# PLAN COMMISSION STAFF REPORT

**Agenda Item:** PC Docket No. 22-022

**Application:** **Development Plan**

**Summary:** Discalced Carmelite Fathers of Indiana, Inc. requesting approval of a development plan for a building arcade addition at 1628 Ridge Road.

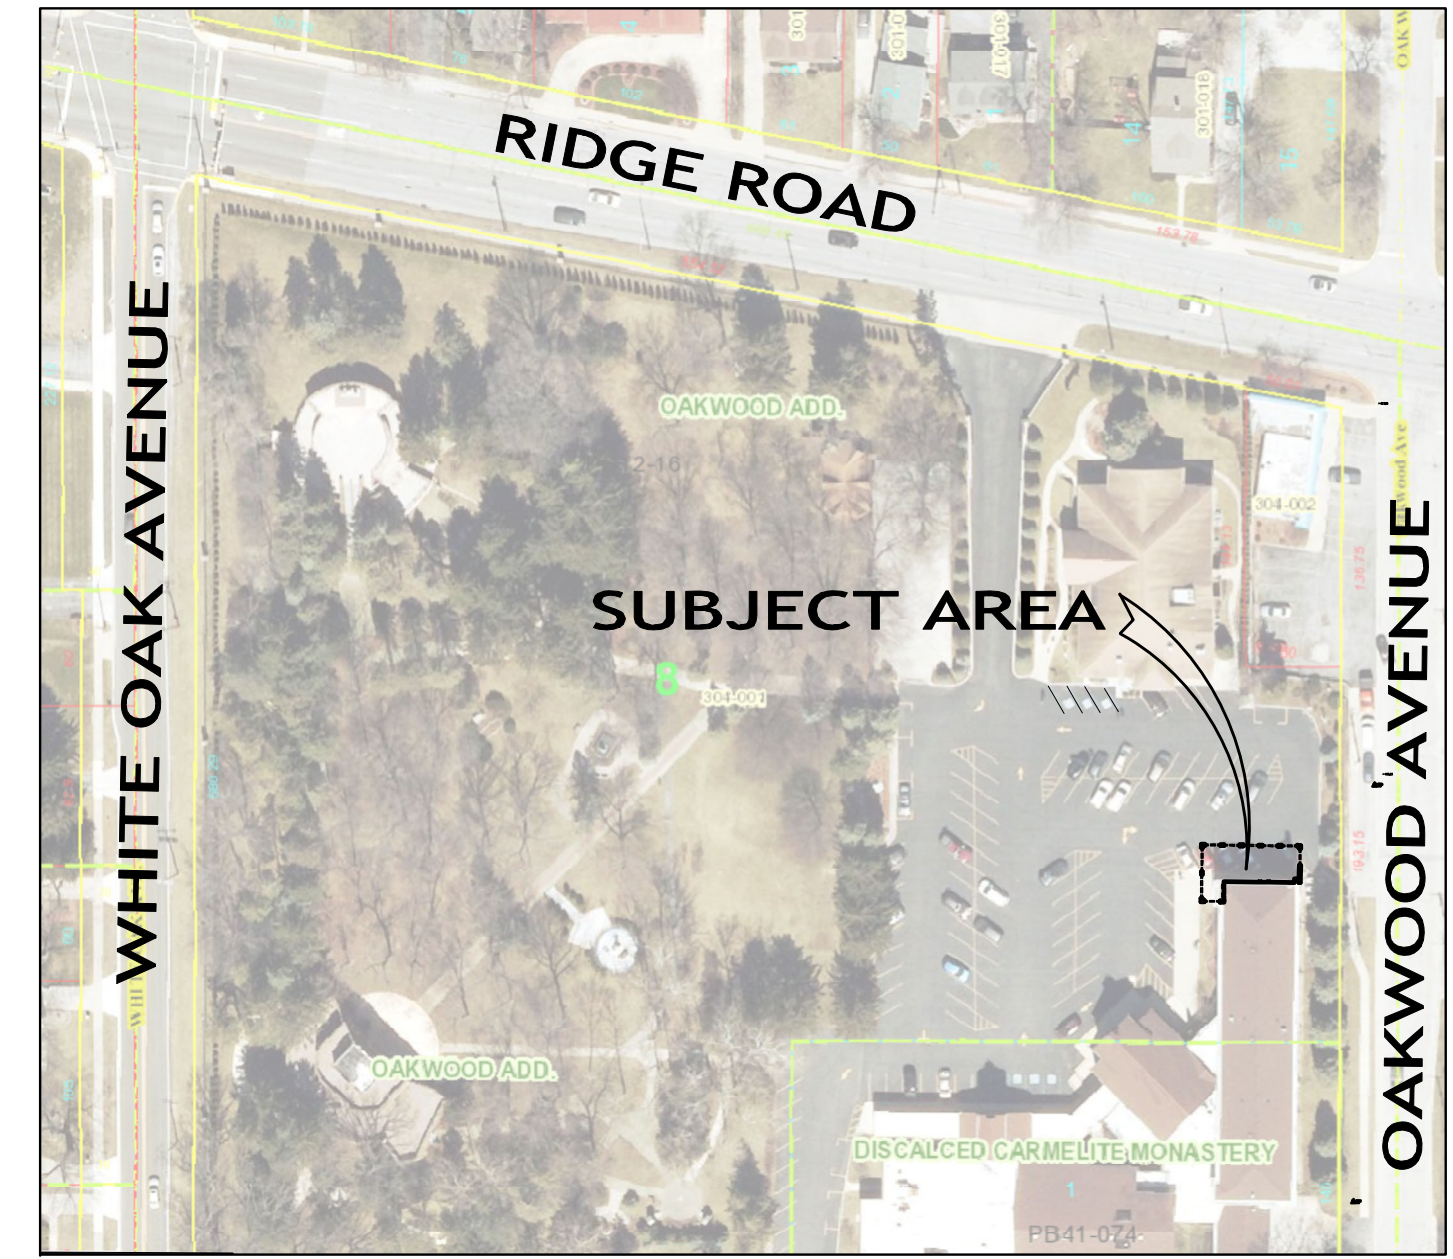
4 parking spaces will be removed to accommodate the drive lane for the new 90-degree parking spaces. The site currently includes 111 onsite parking spaces along with 4 garage spaces, 62 street parking spaces, and an overflow lot to the south on Wilson Street. The required parking for this site is 158 spaces.
